Crosstown™ Stainless Steel Single Bowl Dual / Universal Mount Sink Kit. Overall dimensions are 25" x 22" x 9". Sink is manufactured from 18 gauge 304 Stainless Steel with a Polished Satin finish, Rear Center drain placement and SoundGuard®.

KS-1 KITCHEN SINK

Shop Drawing Submittal Review

Project Name: Webster University-**ISB**

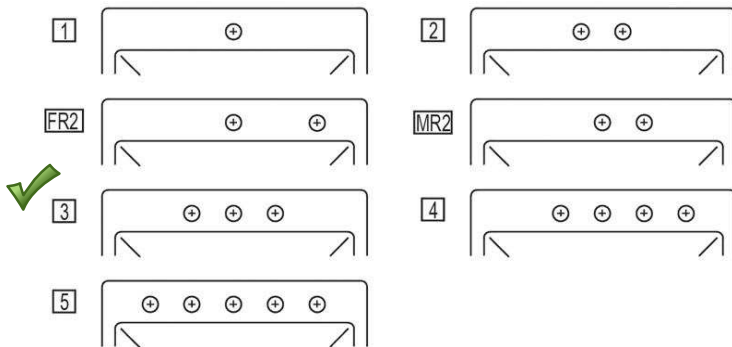
1. Cut sheet indicates a 3-hole punch - verify this with faucet 4-hole punch requirement.
2. Provide under counter waste and supply protective piping covers as required.
Verify requirements with the architectural drawings.
3. Escutcheons are specified to be cast brass. Refer to specification section 220518.
